Subject: **ADDENDUM NO. 2**

Project Name: **Northport FMS #9 Renovations – Northport, AL**

IFB No: AC-22-B-0004-S

C2.1

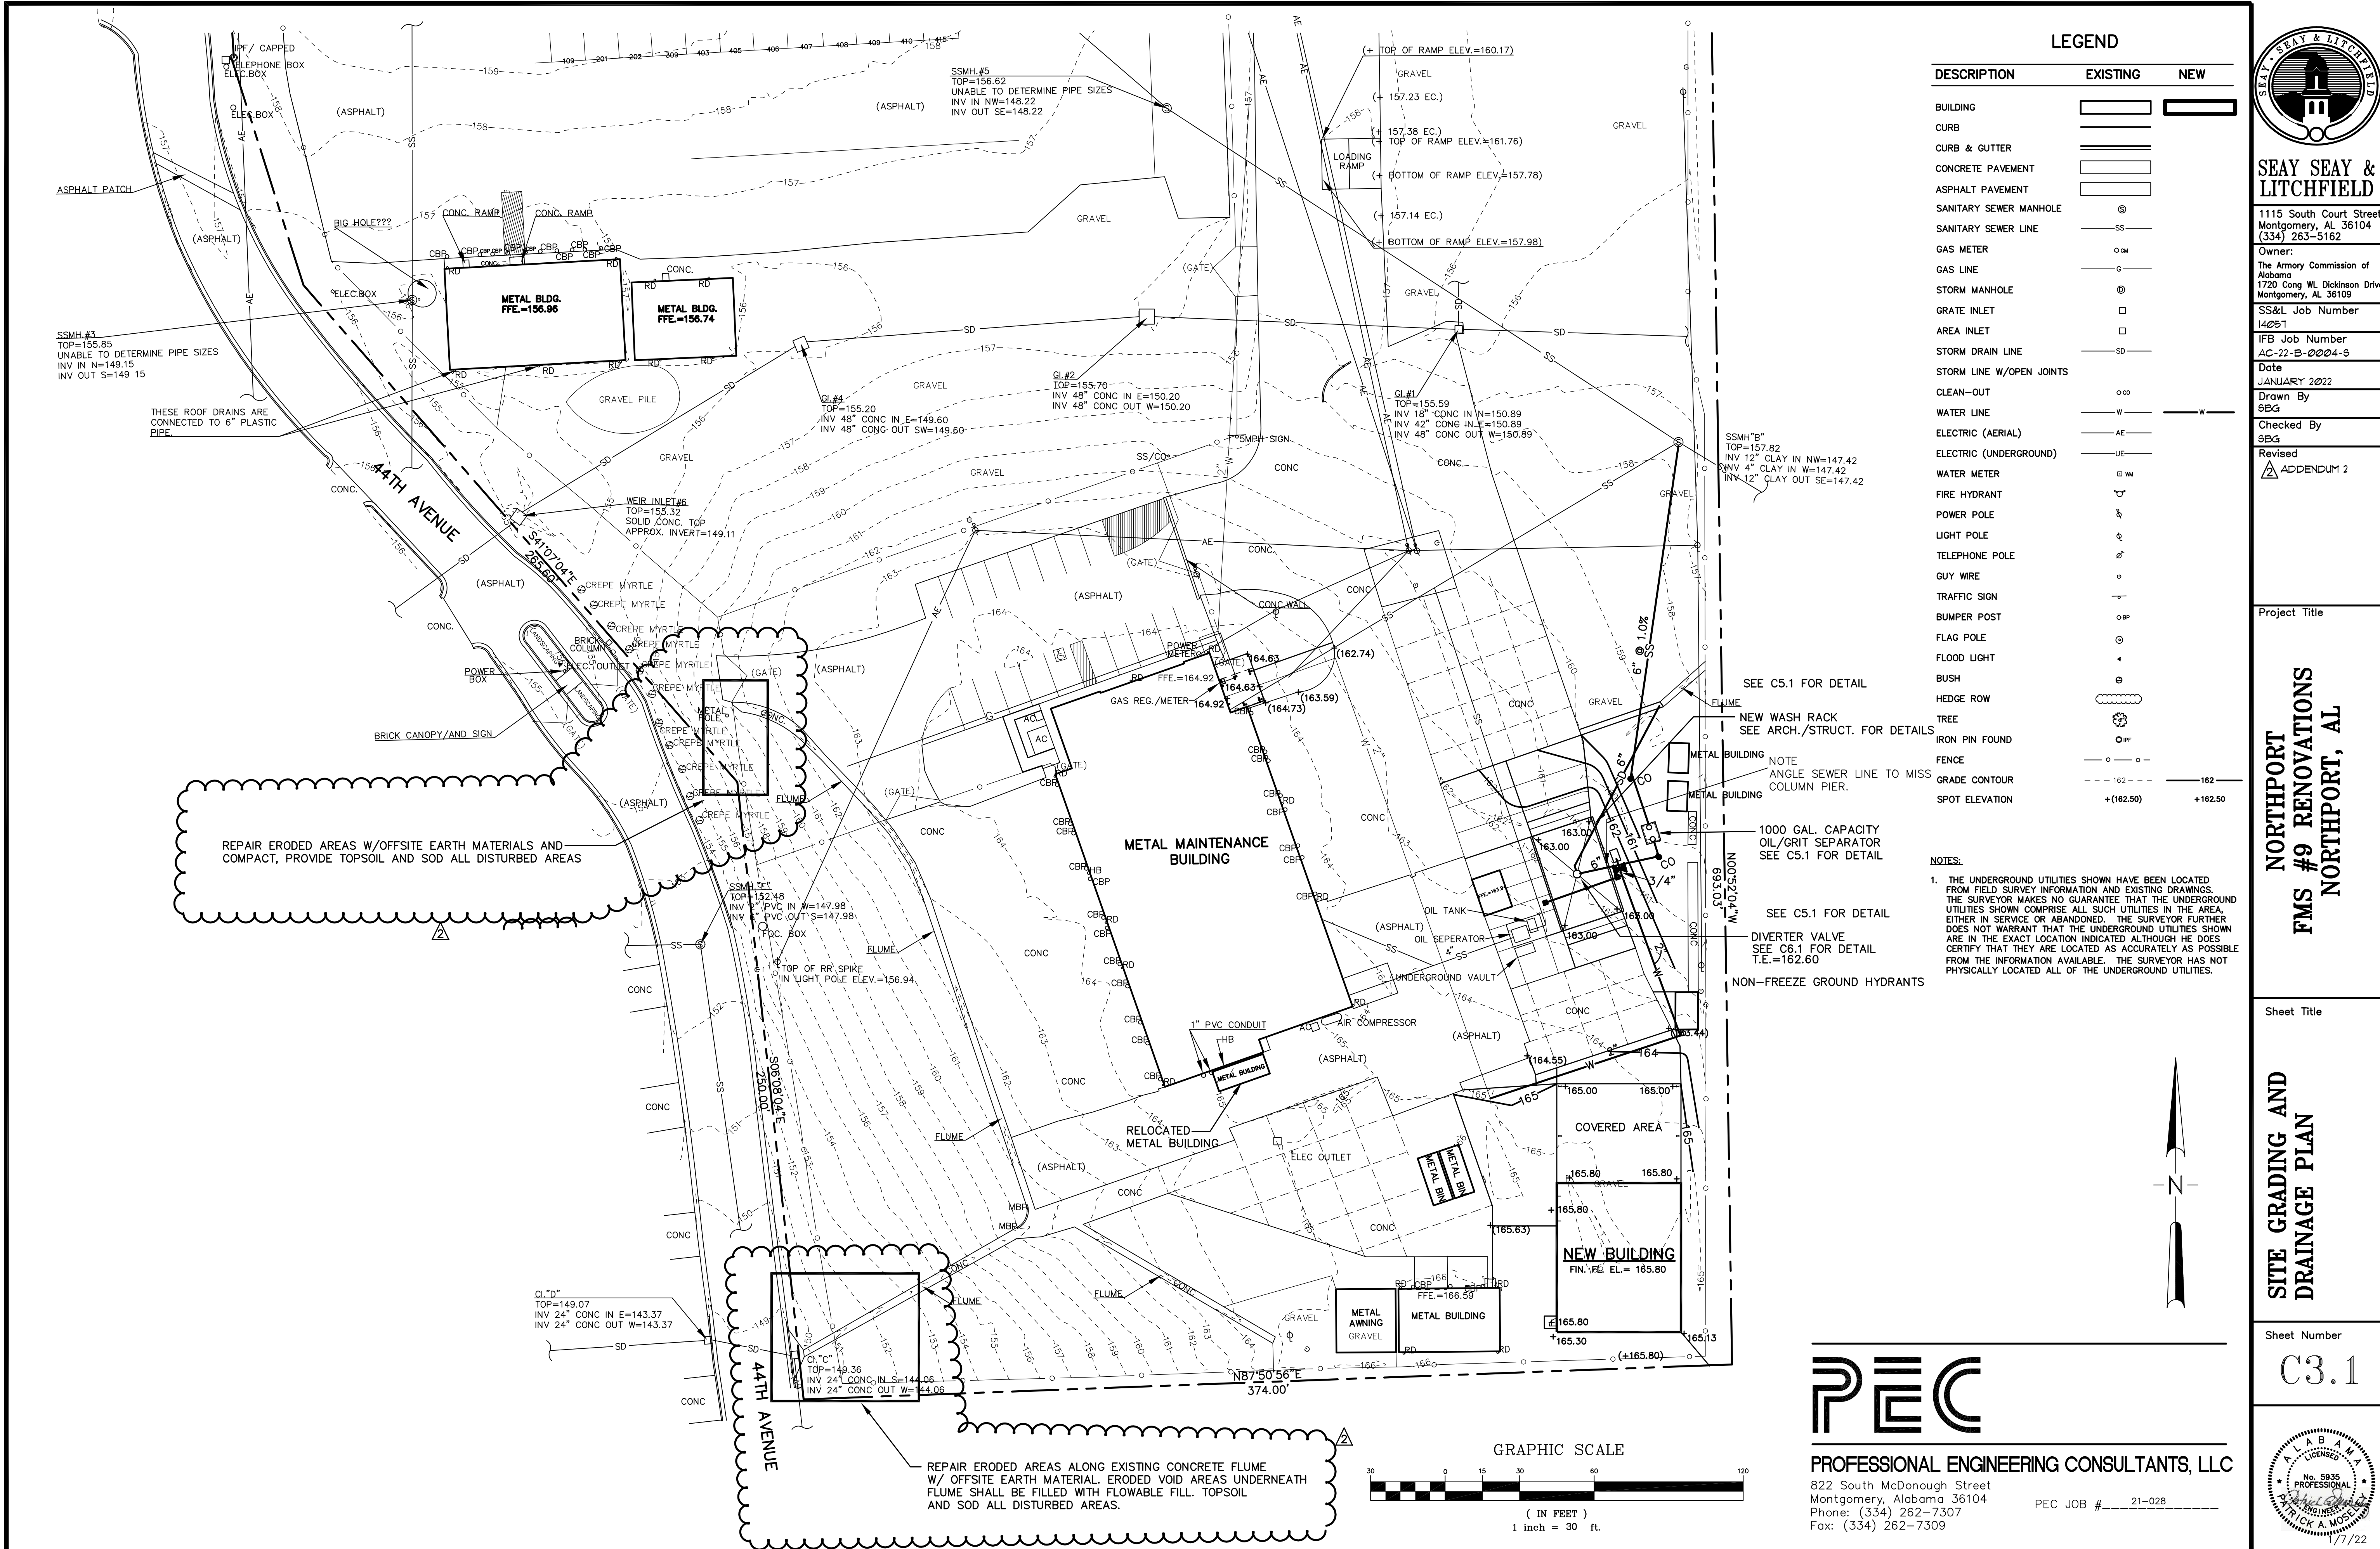
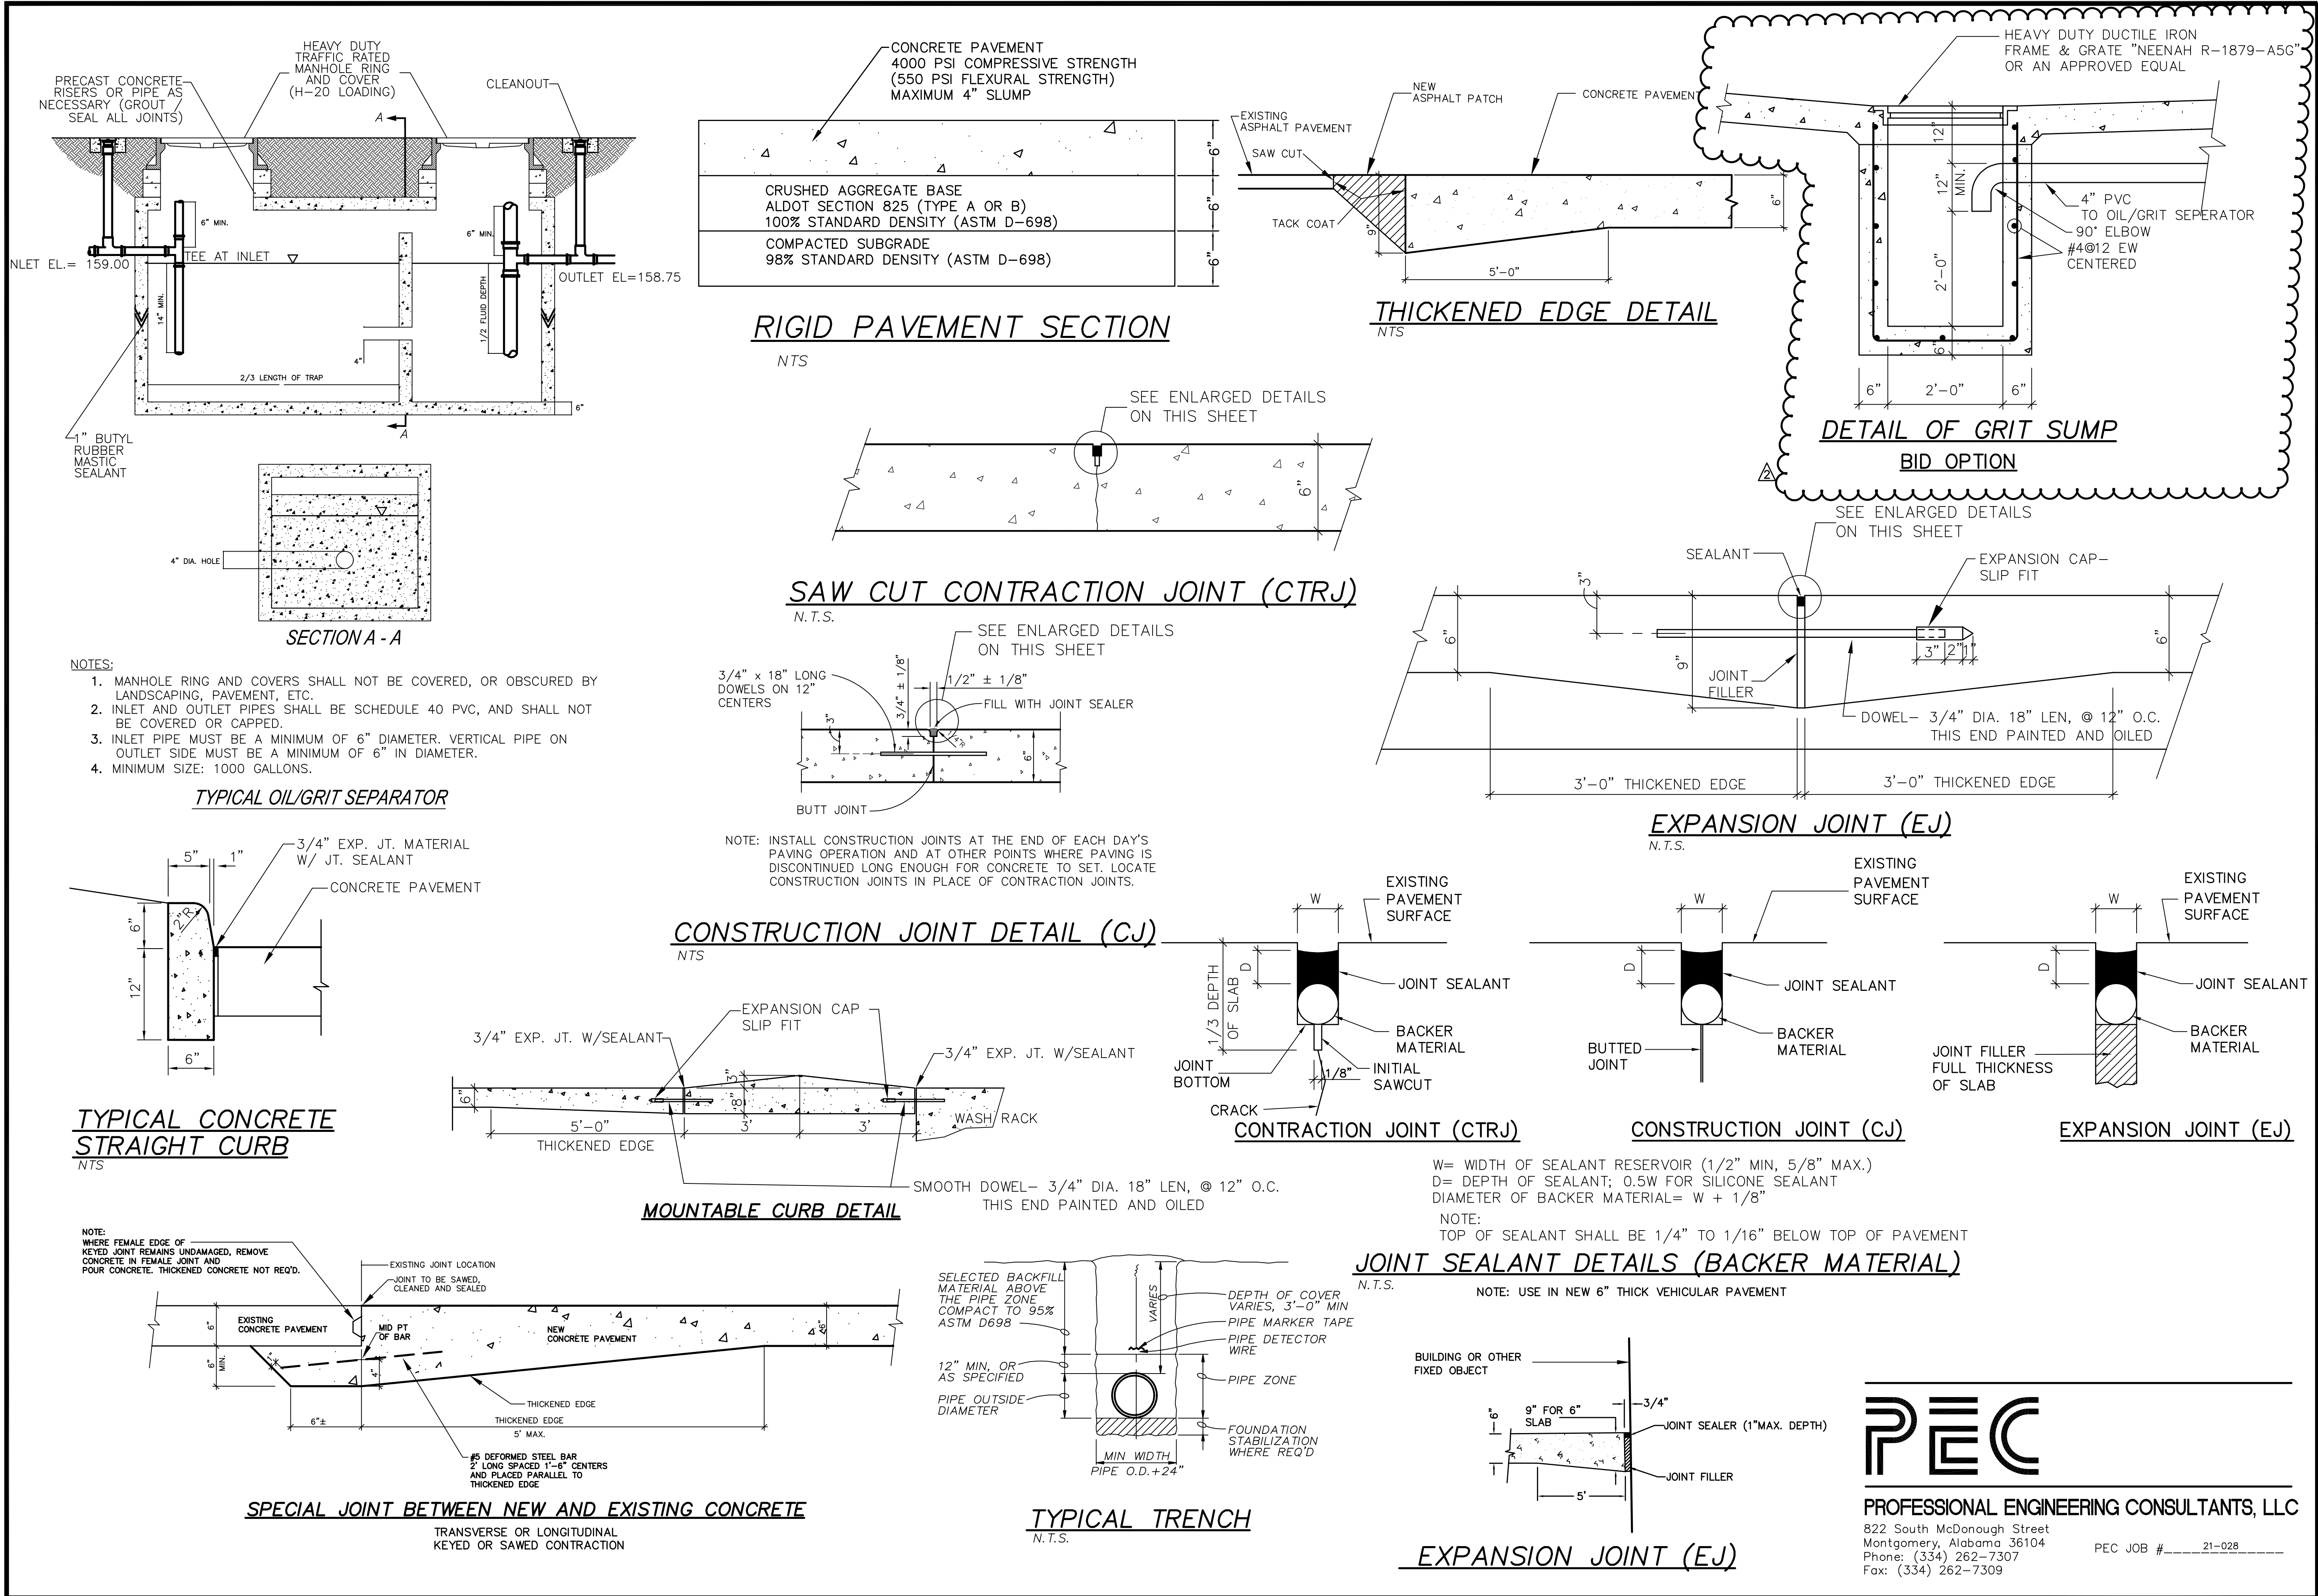
Item No. 11: Refer to attached drawing sheet C2.1 Site Layout and Utilities Plan. As part of Bid Item A. The General Contractor shall include pricing for both the Diverter Valve as detailed on drawing sheet C6.1 and the Manual Diverter Valve as detailed on sheet C2.1. After award, the Owner will select which diverter option to proceed with installation. The amount of the work and materials required for the diverter option not selected shall be credited back to the Owner.

FINISH SCHEDULE,
DOOR SCHEDULE,
& WINDOW SCHEDULE

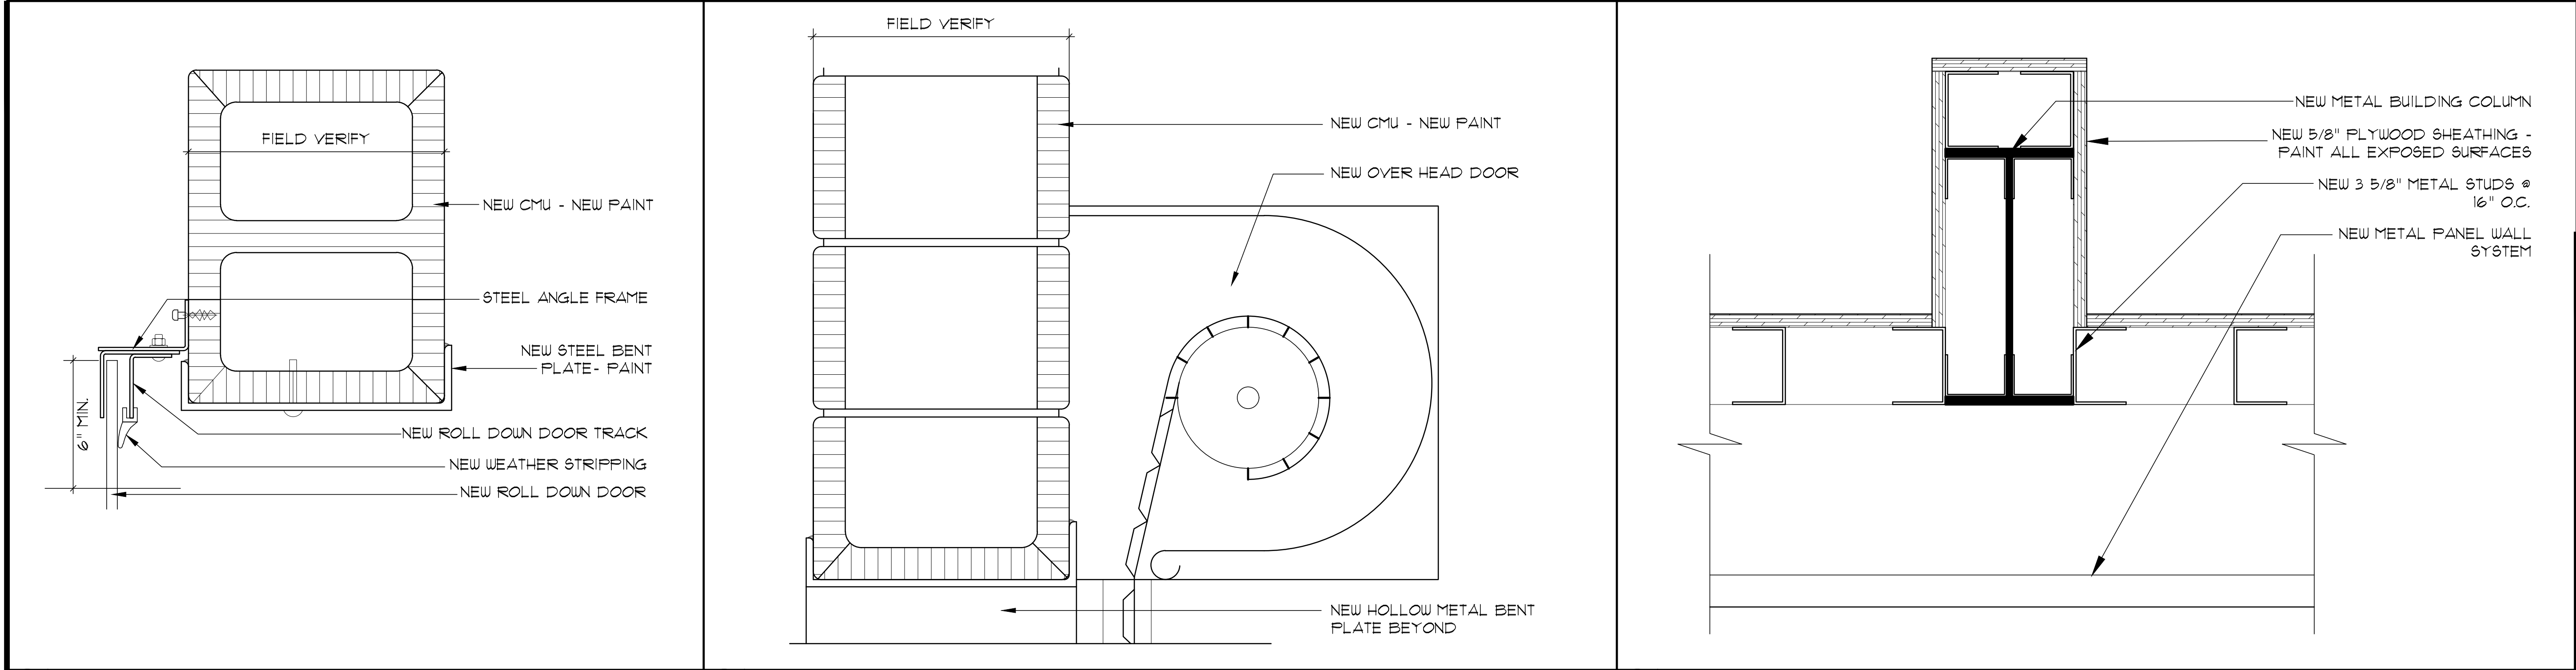
Question: On sheet A3.1 the Finish Schedule calls out "new sealant" on existing concrete. Is this referring to sealing the joints or to sealing the slab?

Response: Refer to revised attached drawing sheet A3.1 Finish Schedule. The sealer to be used is as specified in SECTION 09 9000 Painting and Coating, Paragraph 2.04.G.
